Arboricultural Feasibility Report

The Bourne Estate, EC1N.

Higgins Construction

02.08.16

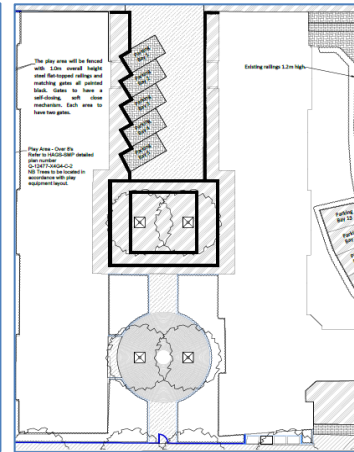
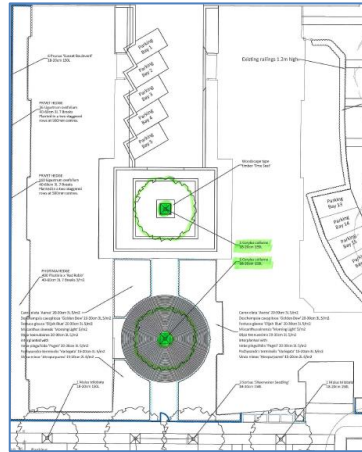
- 2.1.5 The hard landscaping plan originally sought to plant two 18-20cm girth Turkish hazel *Corylus colurna* trees, an updated version then included two parallel specimens either side of the central service lines.

2.2.1 It will not be feasible to plant within the locations, and more suitable planting options are available. Planting within the location will not be suitable for the following reasons:

- The services are shallowly located within the first 500mm below existing ground level. This the minimum depth of substrate required for healthy tree establishment. The majority of the rooting area will be occupied by the services, causing limited root growth and poor establishment.
- Even if the services were adequately shuttered to prevent root damage to the runs from intertwined growth, future maintenance of the services would likely cause significant root damage and unnecessary constraint to maintenance operations.
- Following the extensive utility works involved in installing this number of services in the location there is a high likelihood that the substrate is compacted, void of organic matter and nutrient deficient with an unbalanced pH level. The sum of these factors creates an environment which is unsuitable for tree establishment.

- 2.3.1 Contact has been made with the project landscape architect, Mark Cooper BA(Hons) DipLA CMLI Chartered Landscape Architect; to discuss alternative options. We concluded that the most suitable option would be the inclusion of one large planter in each location (1.8m x 1.8m x 1m deep), which incorporated seating/bench structure around the outside.
